**Additions and Renovations
Platt Technical High School
Milford, CT**

ADDENDUM NO. 5

August 15, 2019

MEZZANINE FRAMING PLAN - AREA F
SCALE: 1/8" = 1'-0"

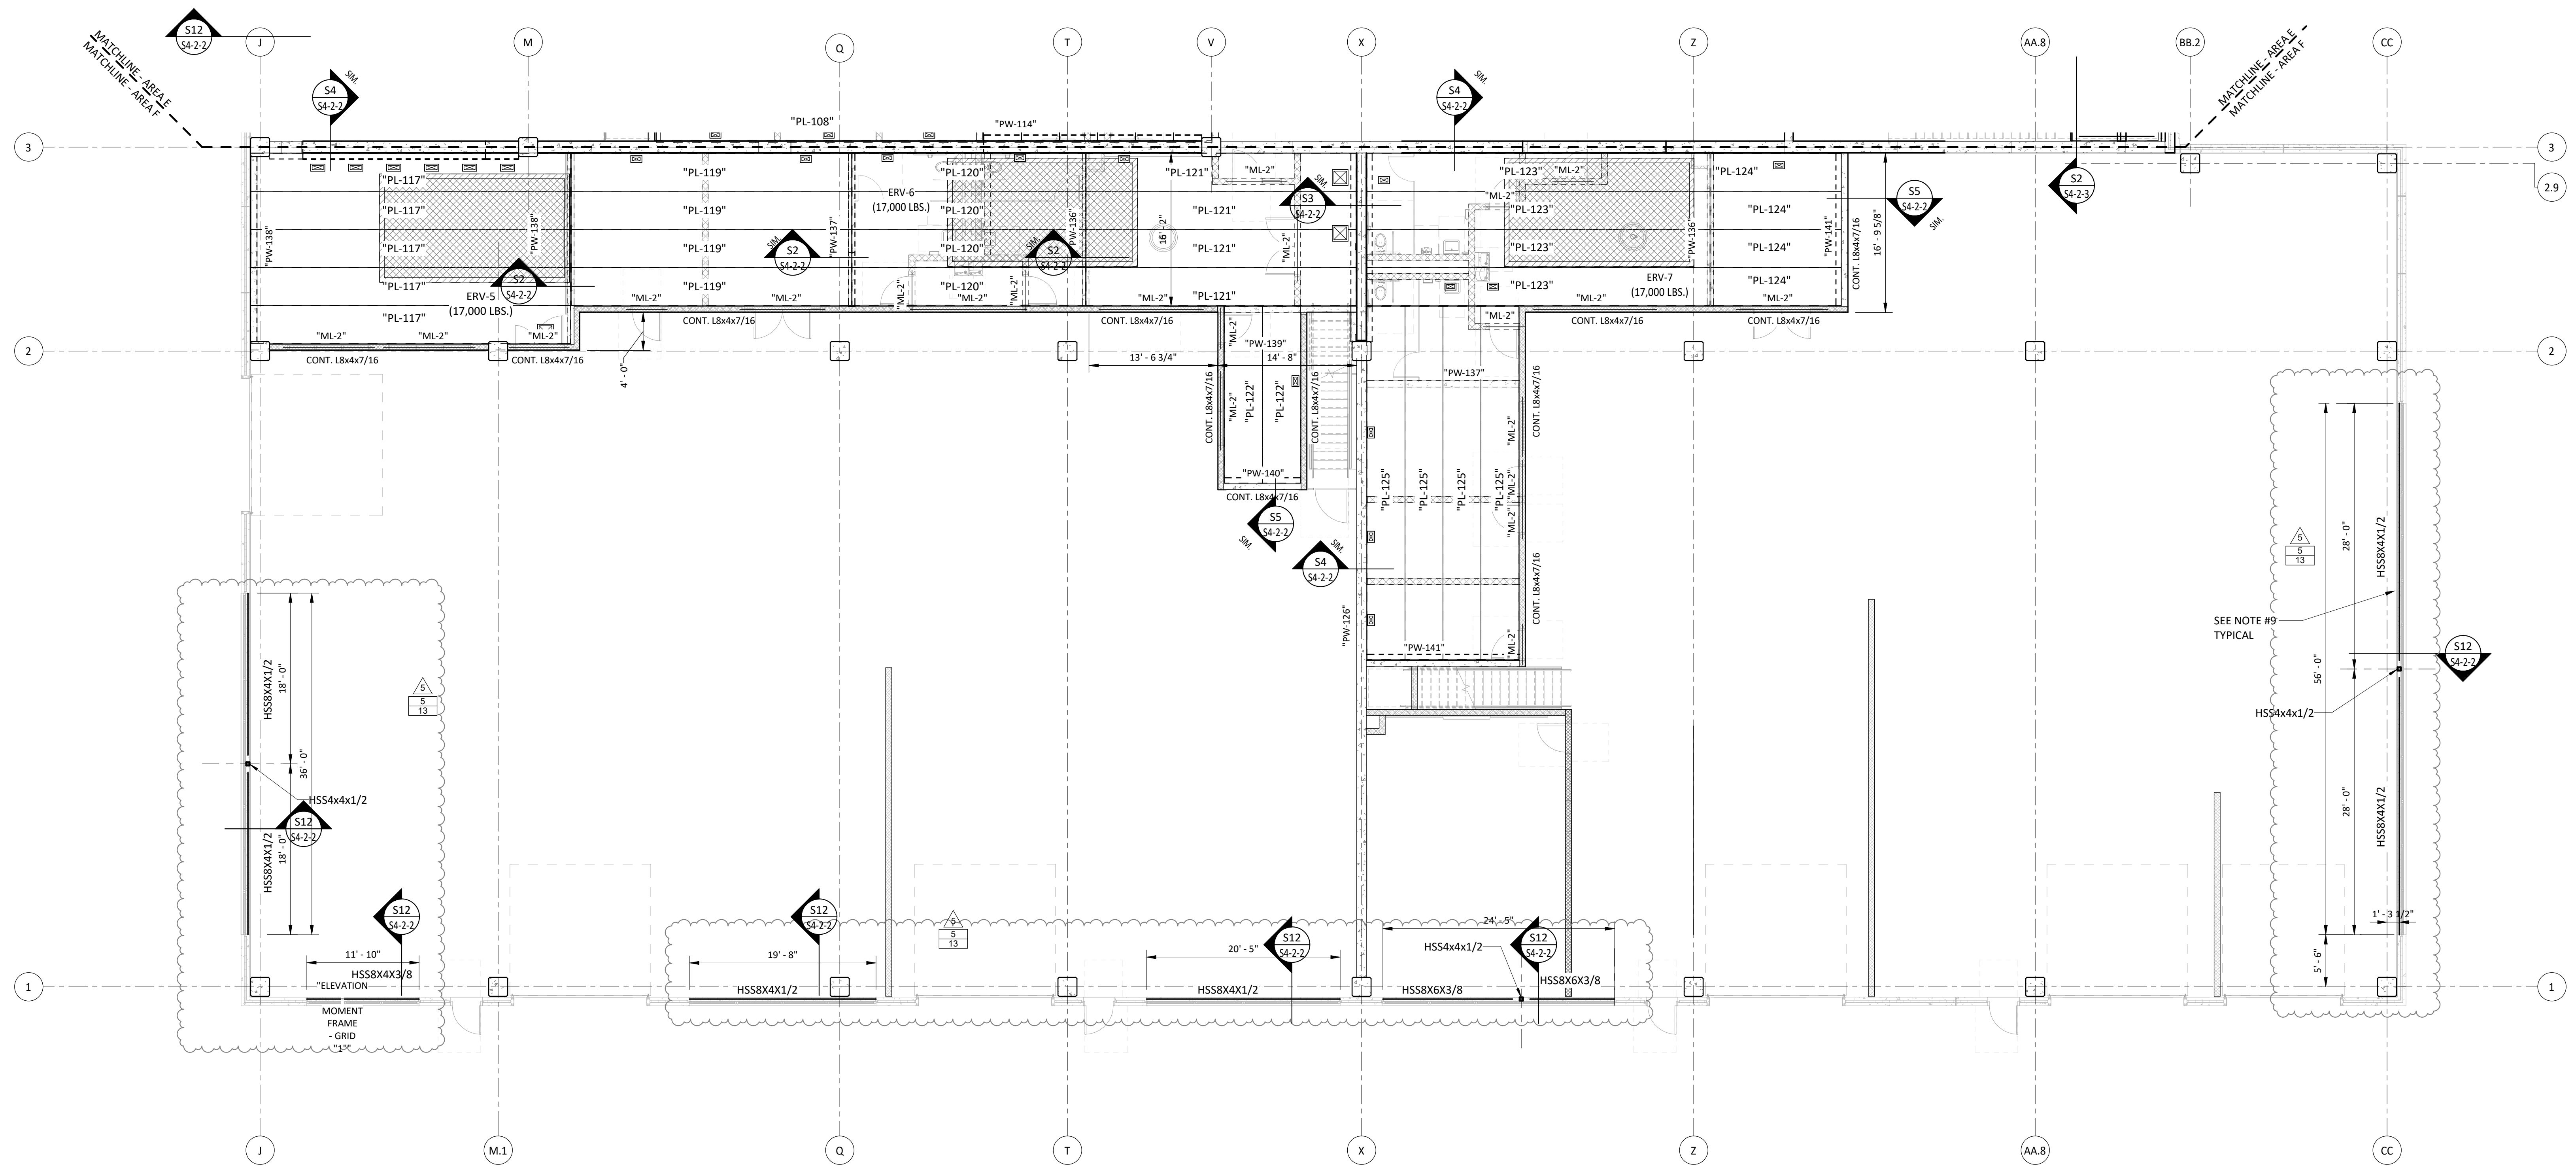
- ADD 5-046 DRAWING S1-1-MF – MEZZANINE FRAMING PLAN – AREA F**
 ADD wall girts per Revision 13.
- ADD 5-047 DRAWING S2-3-1– PRECAST WALL ELEVATIONS**
 ADD wall elevation per Revision 11.

SECTION S6
SCALE: 3/4" = 1'-0"
S4-2-1

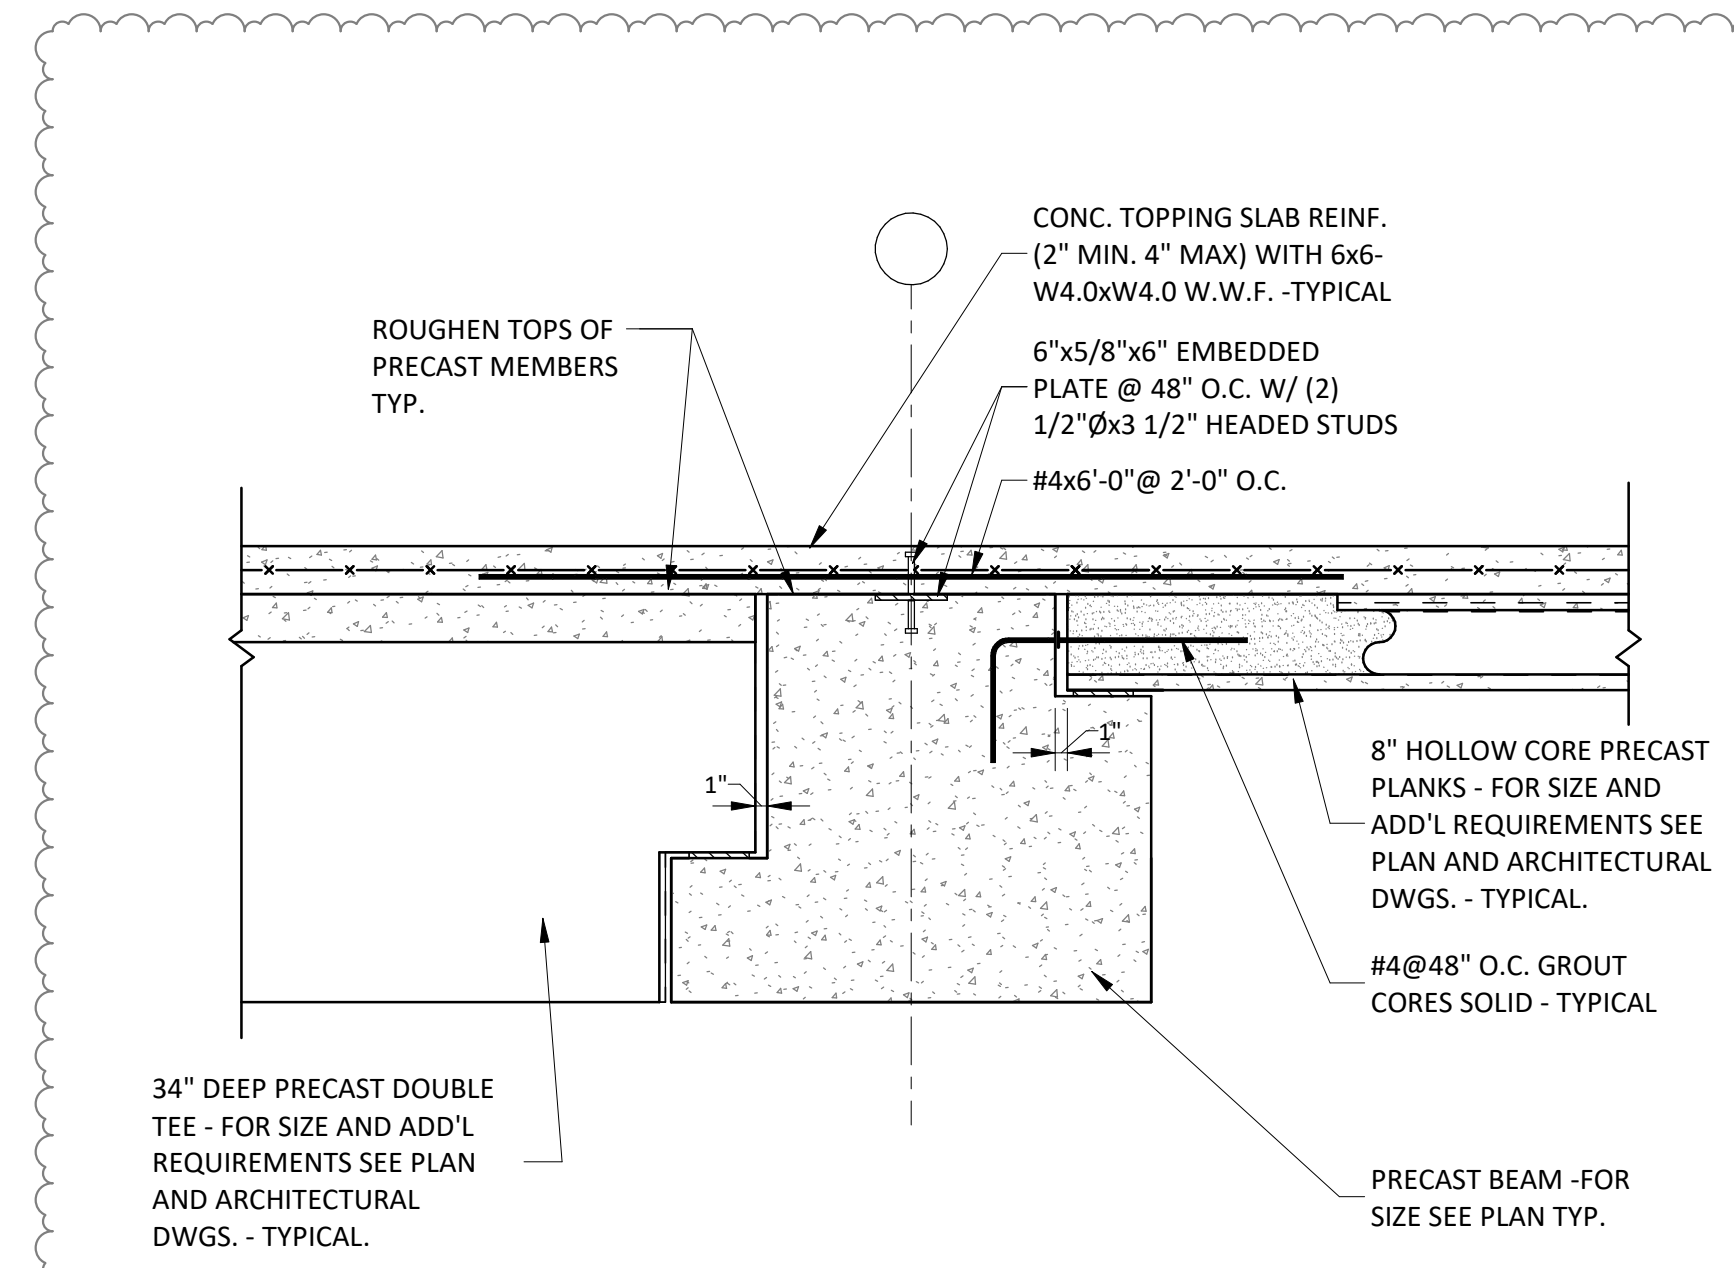
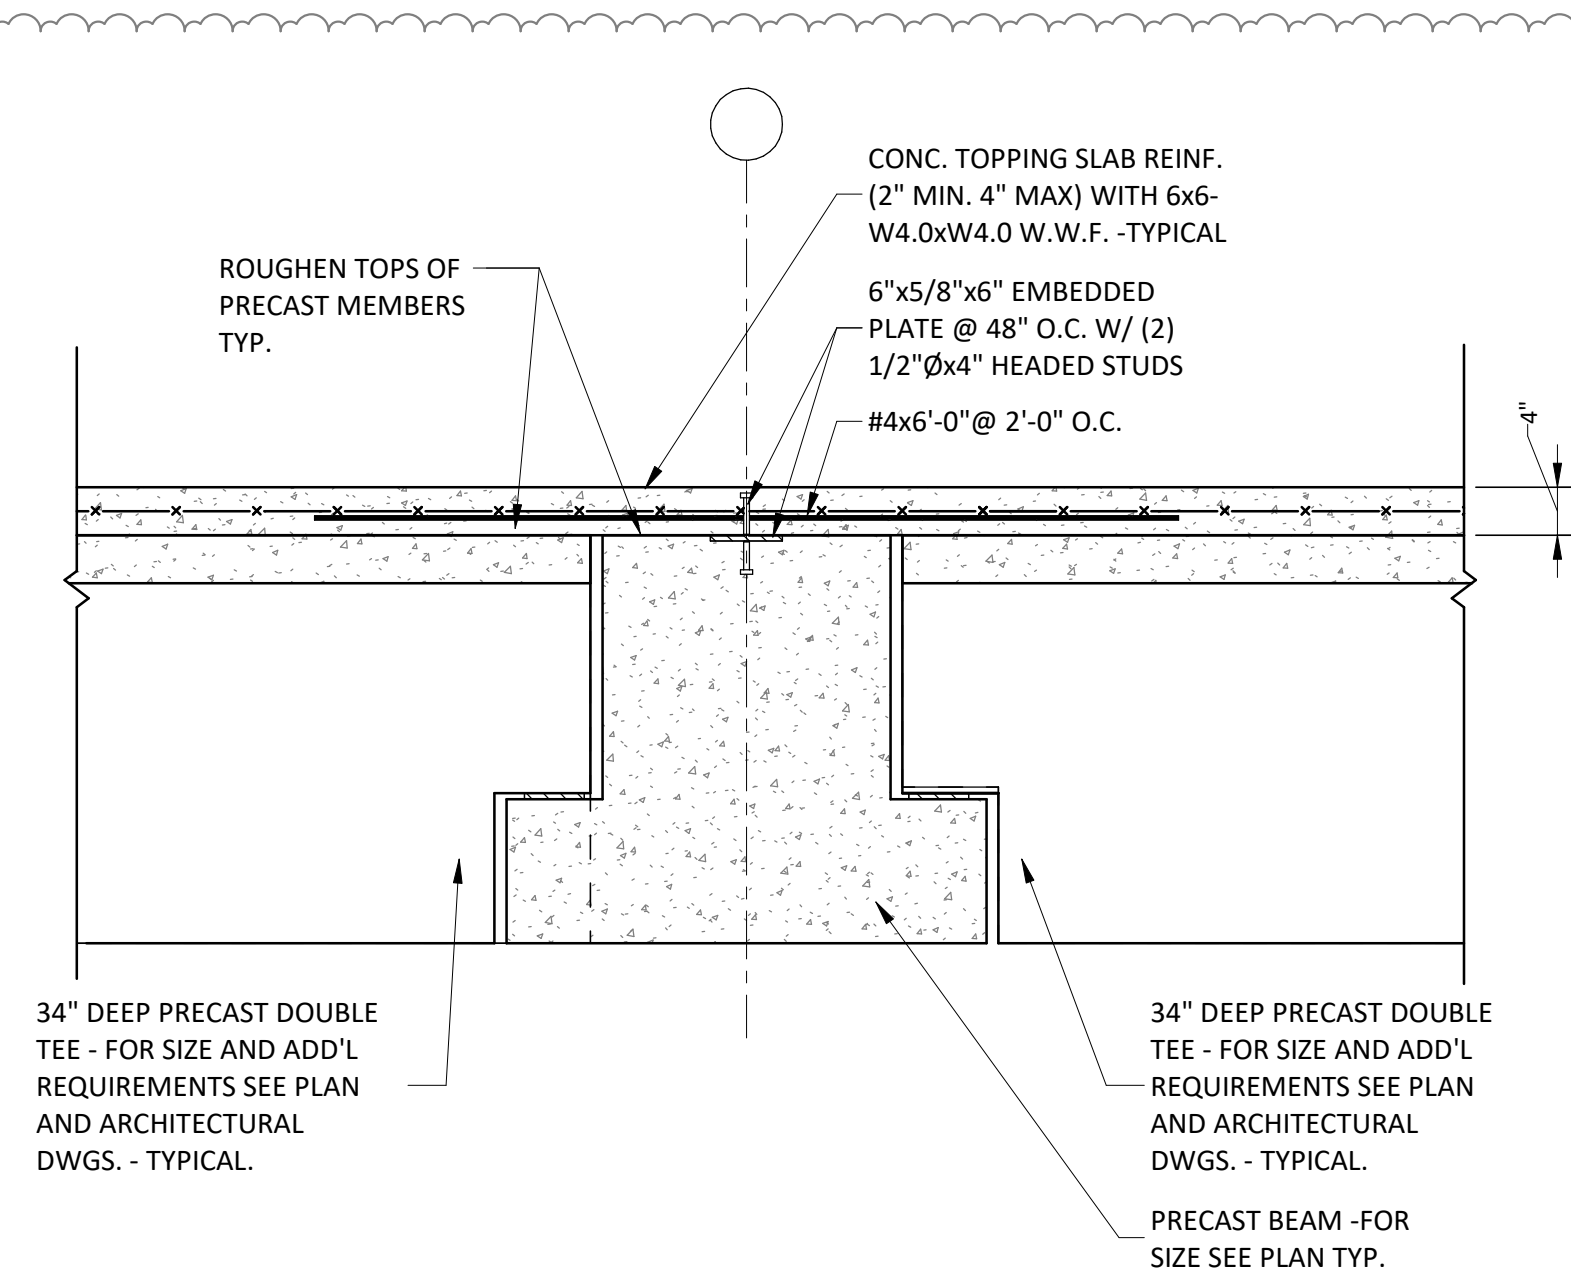
- ADD 5-052 DRAWING S4-2-1– STRUCTURAL SECTIONS**
 REVISE sections "S5" and "S6" per Revision "10".
 ADD sections "S7" and "S8" per Revision "14".

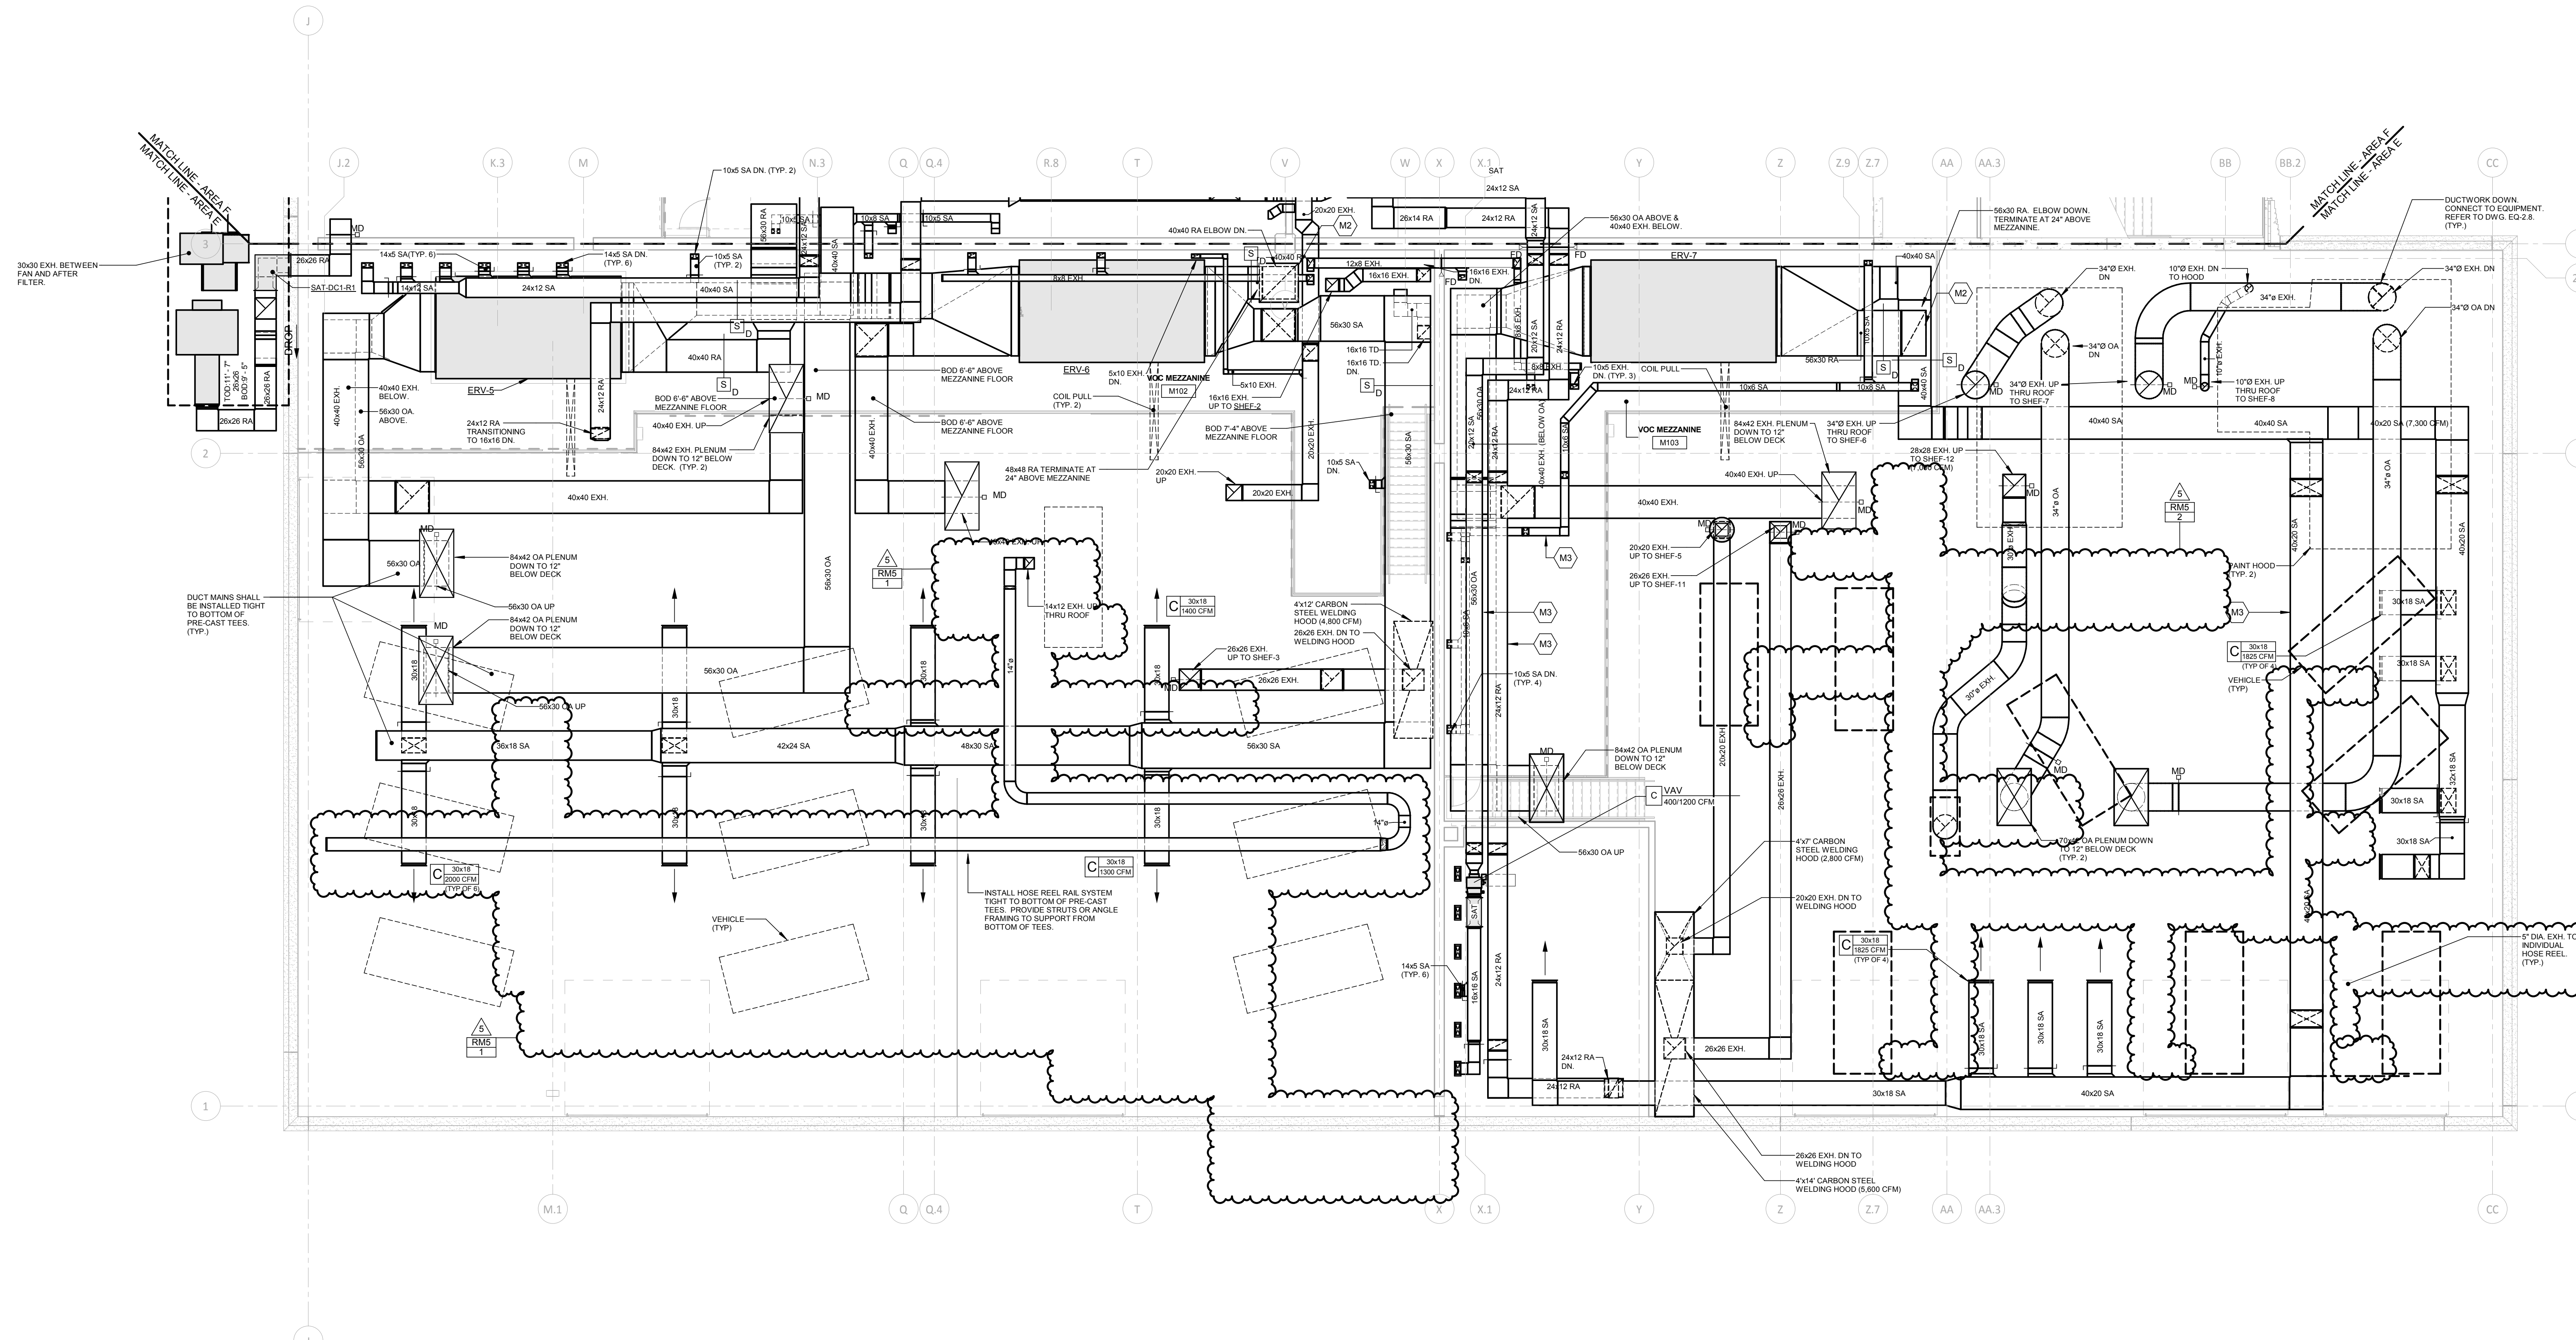
- ADD 5-053 DRAWING M1-1-MF – MEZZANINE MECHANICAL PLAN AREA F**
 Removed exhaust air ductwork and accessories related to VEF-1 and the vehicle exhaust system / hose reels located in Auto Mechanics. Added hose reel rail system to serve VEF-1 per Revision RM5-1.
- Removed exhaust air ductwork and accessories related to VEF-2 and the vehicle exhaust system / hose reels located in Auto Collision F115 per Revision RM5-2.
